バングラデシュ支援事業 速報(建築関係)

2008.02.26

Proposed Plinth House designs for the Sidr affected People of Bangladesh

PROJECT
CONSTRUCTION OF
LOW COST HOUSE FOR
SIDR AFFECTED AREAS

Key Plan

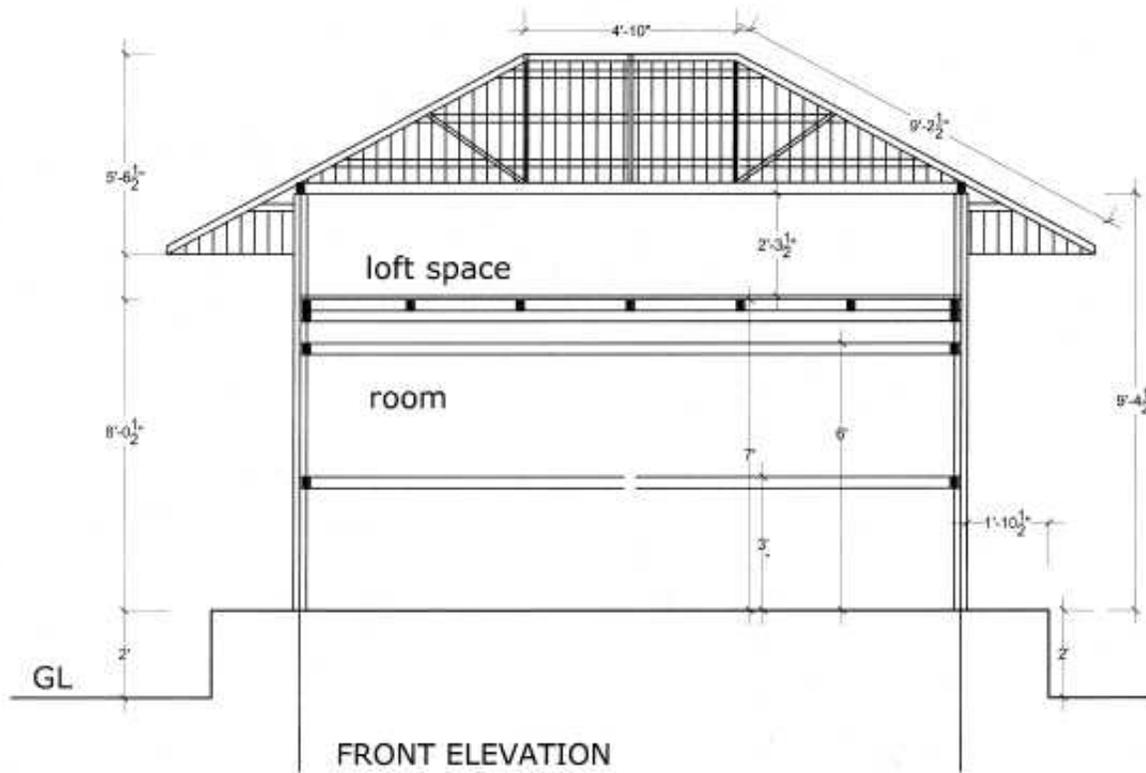
2. Plan

It is better that the span plan are 3 in the short direction, and 4 or 5 in the long direction, because of the wind resist wall setting.

3. Wind Resist Wall

The L shape walls place at each corners.
The walls are made of the wood timber brace, or the earth wall with bamboos, or the plywood.

DETAIL 01

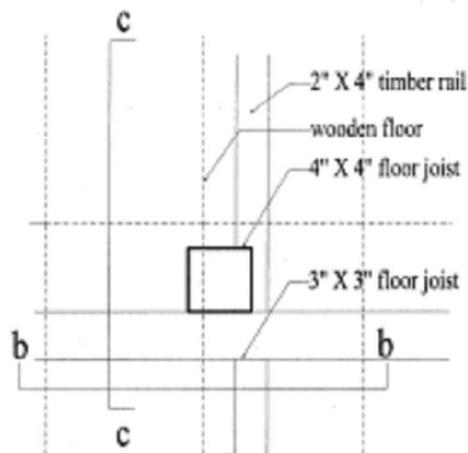
4. Anchoring.

The nail has the small strength. The nails are used for the plywood connections with the columns and beams, its pitches are 10cm.
The bolt has the large strength. It needs to use the drill.

5. Metal Trapping

Metal trappings are made from the steel flat bars with 1.2 ~ 1.6mm thickness and 50mm width.

If the plating factory is In Dhaka,

the metal trappings are galvanized in the last process.

If not, the metal trappings are made from the galvanized steel flat bars, with the tach up paint process.

The diameter of the bolts are 13 ~ 16mm.
